AGENDA
HISTORIC LANDMARKS COMMISSION

HISTORIC LANDMARKS COMMISSION MEETING

SUBJECT: REQUEST FOR EXTERIOR ALTERATION (EX13-09) BY KARL JOHNSON AT 674 17TH STREET

Comparison of proposed heights as viewed from the south

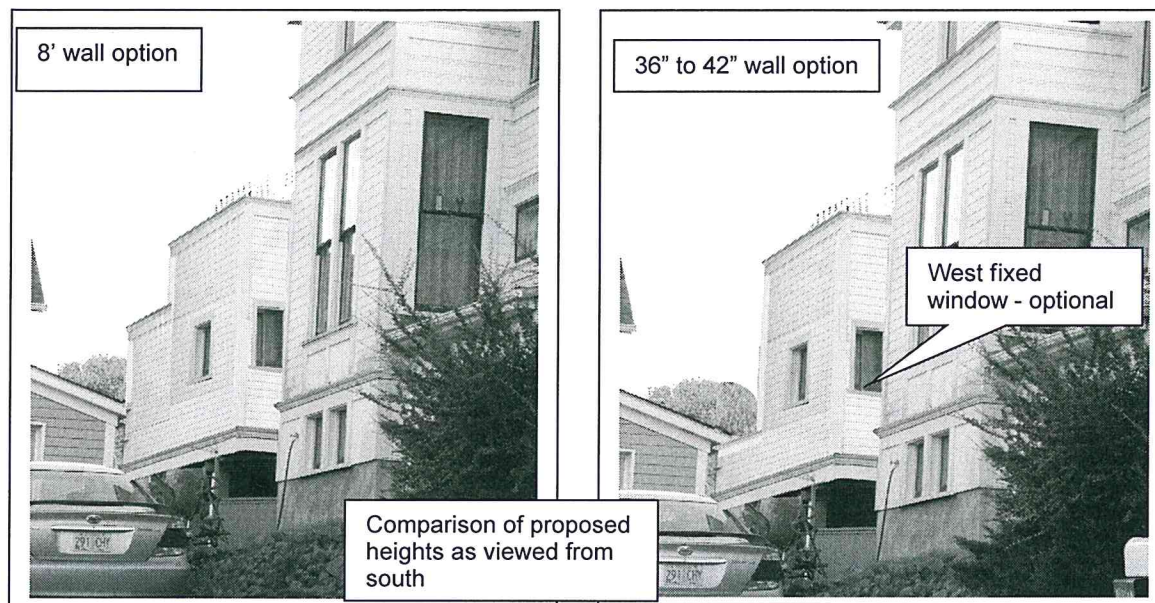
The second floor deck railing would be located in line with the main house rather than out at the edge of the wall. The side walls of the first floor deck would be reduced in height. The applicant requests that the wall height be reduced by about 4.5' for an approximate height of 8'. He states that the higher wall is needed to provide privacy on the deck and for the neighbors to the north as the deck is at the same height and very close to their bedroom window. A second option would be to reduce the wall to the height of the first floor deck balustrade resulting in a height of 36" to 42". Staff have prepared photo simulations of both options. Both options result in less mass of the building addition than what was originally proposed. The higher wall does allow more privacy and also blocks more of the view of the spiral staircase as viewed from the neighbor's house to the south. The HLC will need to determine if the applicant's request for the higher wall reduces the mass sufficiently.

674 17th Street -- South Elevation

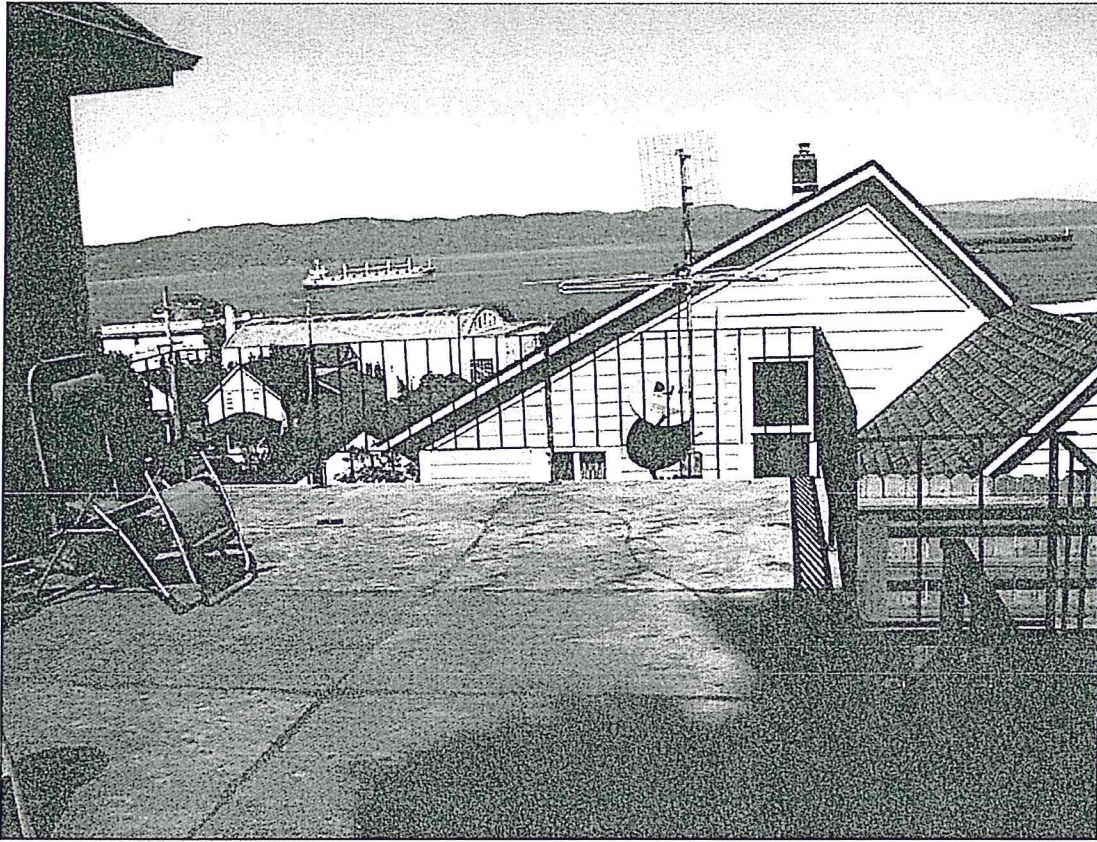
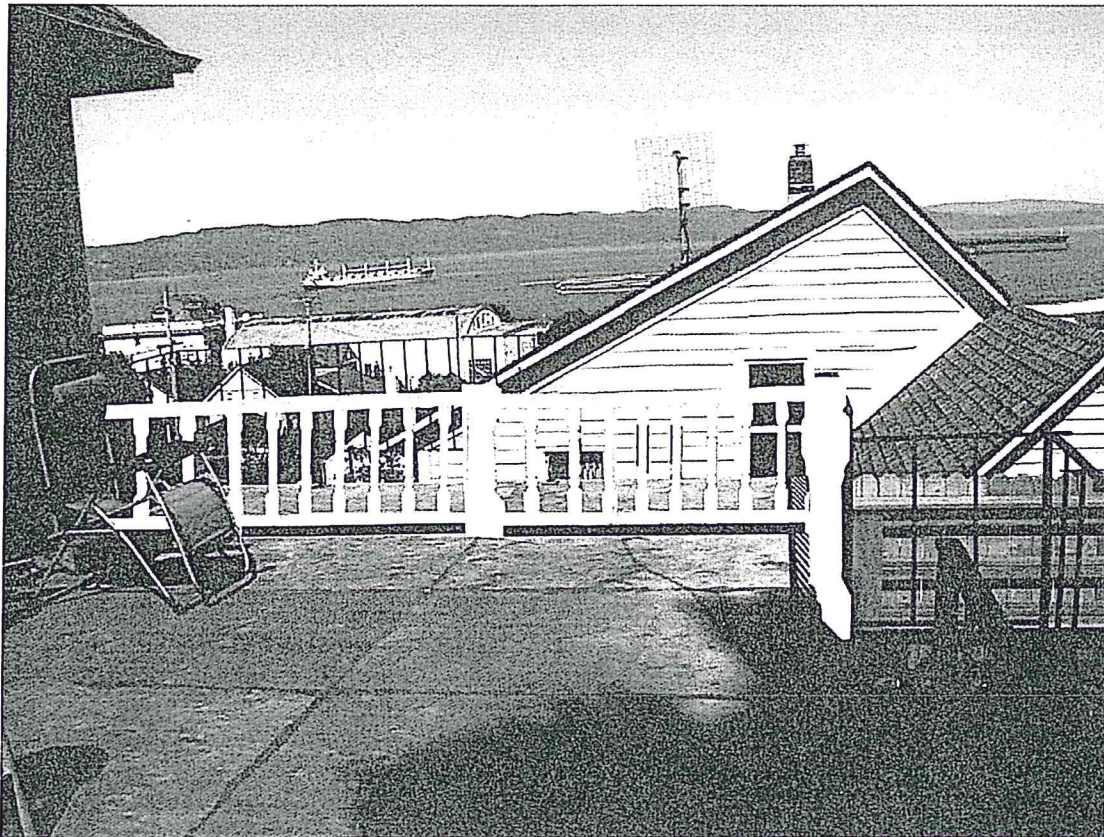
1. The height of the side walls of the second story deck shall be limited to approximately the 36" to 42" height of the first floor deck balustrade **(OR)** approximately 8'. ***(HLC to determine which height to include.)***
2. The window on the west elevation is optional.
3. The ceiling material shall not be vinyl.
4. The design of the spiral staircase railing shall be reviewed and approved by the Planner.
5. Any needed visible support posts shall be wrapped, trimmed, or chamfered to create detailing on the posts.
6. The plywood flooring shall be surfaced with another material or finished with a stain or paint.
7. The east elevation wall/balustrade for the first floor deck shall be sided and finished to match the house.

#2—PRE-EXISTING NORTH+ SOUTH WALLS WERE NEVER AT EAST RAILING HEIGHT OF 36IN.
BUT I WILL REMOVE AS MUCH AS POSSIBLE AND STILL MAINTAIN MY (AND THEIR) PRIVACY.

IF I TAKE N. WALL DOWN TO EAST RAILING @ 36IN. I WILL BE STARING INTO ONE OF THE NEXT
DOOR NEIGHBORS BEDROOM WINDOWS. - *N. WALL TO REMOVE*
8' X 4'6"

Proposed by staff

Proposed by staff
